BCDC COMMITTEE

JAN 14, 2020

449 CAMBRIDGE ST, EMERY RD PARCEL IN ALLSTON

ANCHOR↓LINE
PARTNERS

C - RUGG ROAD STREETScape PLAN

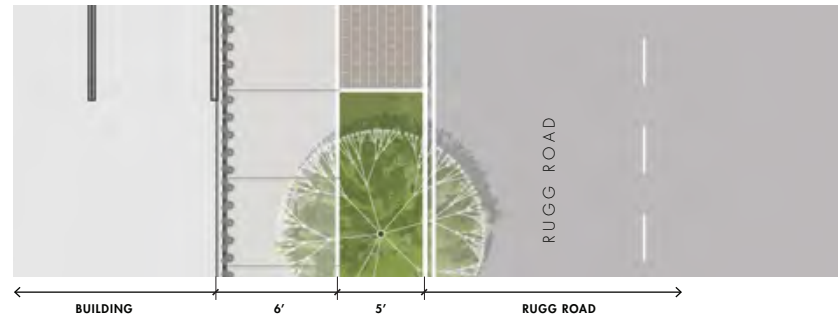
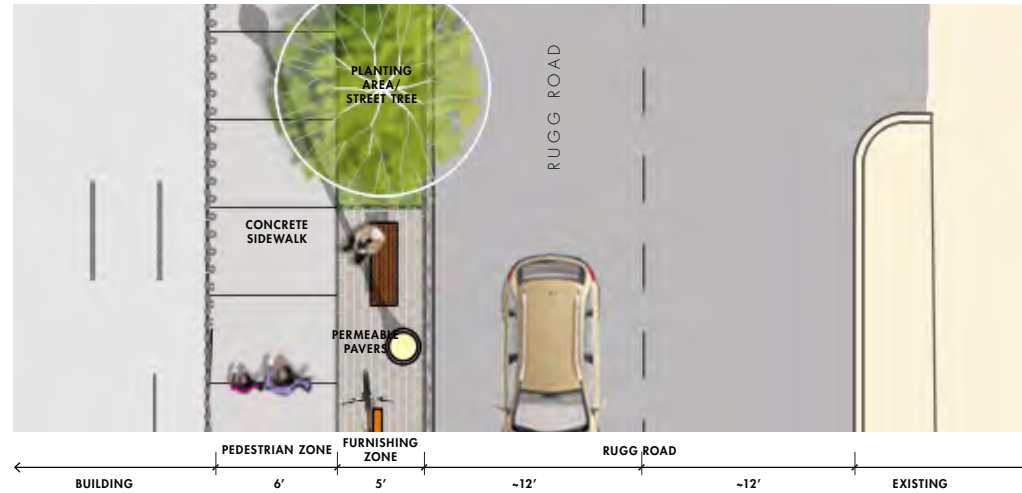
PREVIOUS DESIGN

CURRENT DESIGN
